UNITED STATES PATENT AND TRADEMARK OFFICE

10/789,496

Office Action Summary	Application No. 10/789,496	Applicant(s) NEMIR ET AL.	
	Examiner MINH D. A	Art Unit 2821

DETAILED ACTION

FIG. 3

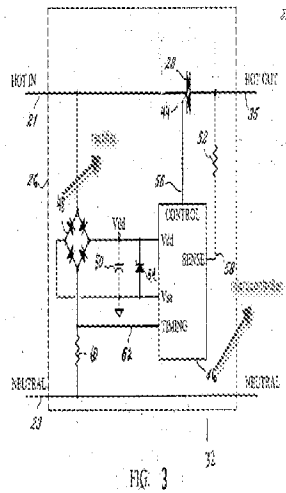
Claim 52 is rejected under 35 U.S.C. 112, first paragraph, because the specification, while being enabling for "a microcontroller (46); and electrostatic discharge protection diodes(66 and 68) internal to said microcontroller(46) and excluding rectification elements(rectifier) of a DC power supply external to said microcontroller(46) as show in figures 3 and 5 above", does not reasonably provide enablement for **the diodes(66-68) paralleled by a MOSFET transistor(74 or 76) that forms an alternative conducting path around said internal electrostatic discharge protection diodes(66-68)**". The specification does not enable any person skilled in the art to which it pertains, or with which it is most nearly connected, to the diodes (66 and 68) paralleled by the MOSFET transistors (74 or 76) into the microcontroller(46) the invention commensurate in scope with these claims. Further more, Figure 4, only disclose the MOSFETs and diodes (66-68) are connected to input buffer and do not how to connect or store into the microcontroller (46) or any device or component can be associated into the microcontroller (46) as show in figures 3 and 5 above.

Comment [D01]: You're saying one of ordinary skill would not be able to connect a MOSFET in parallel with the diodes? If that is correct, your rejection seems unreasonable.

FIG. 4

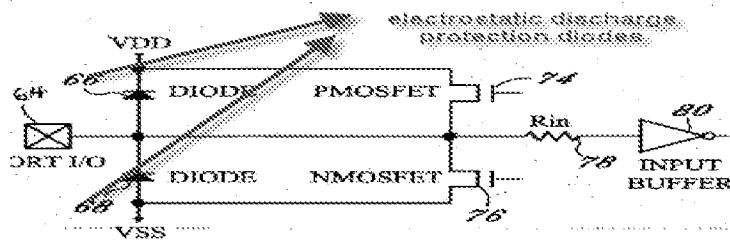
Regarding claim 52, an apparatus for powering an electrical network comprising: a programmable controller comprising a microcontroller(46); and electrostatic discharge protection diodes(66 and 68) internal to said microcontroller(46) and excluding rectification elements(rectifier) of a DC power supply external to said microcontroller(46) as show in figures 3 and 5 above, now turn on the figure 4 and the limitation from the amendment that, **said diodes(66-68) paralleled by a MOSFET transistor(74 or 76) that forms an alternative conducting path around said internal electrostatic discharge protection diodes(66-68); (as show in figure 4).**

wherein said internal electrostatic discharge protection diodes (66-68) provide a source of direct current for said microcontroller(46).

Comment [D02]: This does not seem reasonable...the claims seem fine to me.

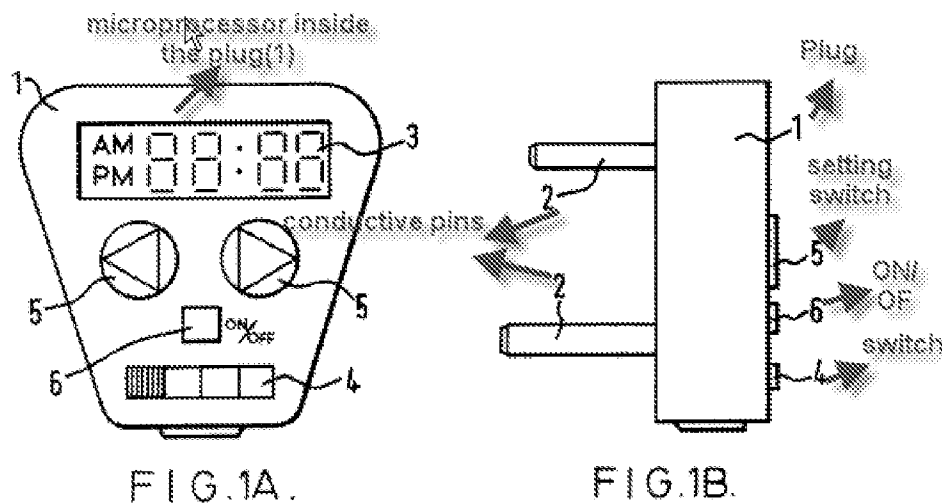
Regarding claim 1, Chi Chuen Chow disclose in figure 1A-1B above that, an apparatus for control of an alternating current appliance, said apparatus being entirely resident within an appliance plug(1), said plug(1) comprising power delivery conductors(conductive pins), and said apparatus comprising a programmable controller (microprocessor inside the plug, see figures 1A-1B above, page 1, lines 53-59) which is programmable exclusively through a plurality of the power delivery conductors (conductive pins).

Regarding claim 27, Chi Chuen Chow disclose in figure 1B above that, wherein said plurality numbers (conductive pins) no more than four.

Regarding claim 28, Chi Chuen Chow disclose in figure 1B above that, wherein two of said no more than four are electrically shorted together such that said plurality of power delivery conductors consists of not more than three electrically unique power delivery conductors(two conductive pins).

Regarding claim 29, Chi Chuen Chow disclose in figure 1B above that, wherein a programming signal is applied to two of said not more than three electrically unique power delivery conductors (two conductive pins).

Regarding claim 30, Chi Chuen Chow disclose in figure 1B above that, wherein said programming signal comprises a series of pulses.

Regarding claim 31, Chi Chuen Chow disclose in figure 1B above that, wherein a data line (data, 1-4 and clock as shown in figure 2A) a clock line of controller (microprocessor) are controlled by application of a programming signal applied to two of said not more than three electrically unique power delivery conductors (conductive pins).

Regarding claim 36, Chi Chuen Chow disclose in figure 1B above that, wherein said programmable controller comprises a microcontroller (microprocessor inside the plug, see figures 1A-1B above, page 1, lines 53-59).

Regarding claim 42, Chi Chuen Chow disclose in figures 1A-1B above that ,a method for control of an alternating current appliance, the method comprising the steps of: providing a programmable controller(microprocessor inside the plug(1) as show in figures 1A and 1B); providing an appliance plug; disposing the programmable controller within the appliance plug; providing a plurality of electrical power delivery conductors(2); programming the controller exclusively by applying one or more signals to two or more of the power delivery conductors(2).
